Record of Executive Business and Chief Executive's Order

Reg. Reference: SD21A/0101

Submission Type: Additional
Information

Location: Nutgrove Avenue, Rathfarnham, Dublin 14

Extract from applicant's Site Layout. Note that the public footpath and cycle path are in white to the north of the internal footpath within the site.

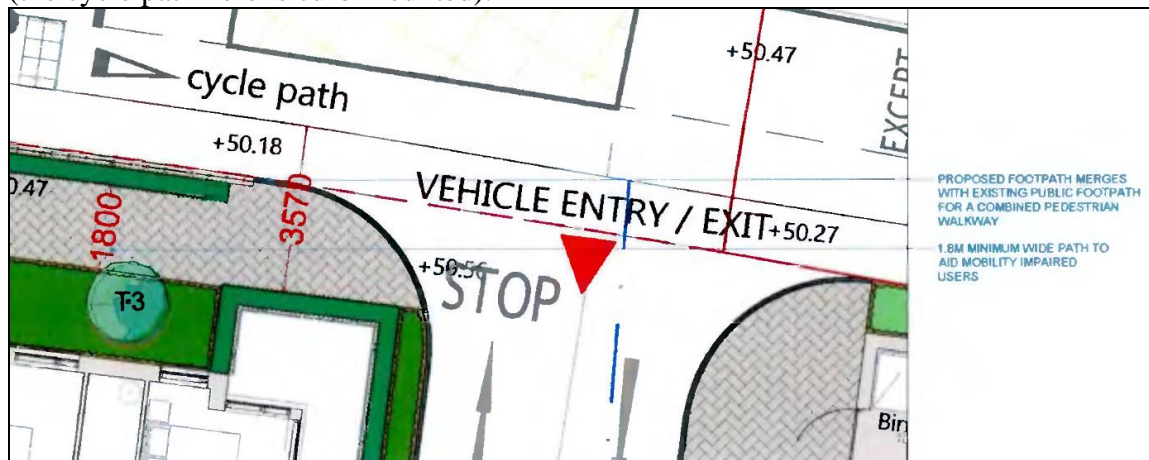
In relation to item 1(3) in particular, it is noted that the drawings submitted show a broad junction radius going through a full 90 degree turn within the site, inside the public footpath and cycle path (the cycle path here is curb mounted).

The applicant's proposal for the footpaths is to have a 3.57m footpath area but with segregation features (hedging) at the edge of the property boundary. This creates a parallel throughway within the site. Of particular concern is the risk that the private footpath may at a later stage be judged to require fencing and restrictive access points, which would detract significantly from the streetscape. It is considered more appropriate to provide a single, wider, footway at this location, without segregating features. It may be appropriate that this footway is taken in charge and adequate privacy strip provided. The applicant may wish to provide **clarification of additional information**.

(b) The applicant is requested to clarify their response to Item 1(3) and clarify the proposed arrangement of the junction. The drawings provided suggest that the curved corner of the junction will be contained entirely within the site - this would be an inappropriate arrangement given the public footpath and cycle path. Works will be required outside the red line of the planning application, i.e. in the public domain, and the applicant should propose a junction layout which includes such works. The sightlines provided should also be adjusted if the position of the 'stop' line changes, as necessary.

(c) The applicant is requested to clarify how the footpath to the front of the development will interact with the public footpath, to ensure that there are not segregating features between the two, that privacy strips as necessary are provided within the site, and to show which areas should be taken in charge.
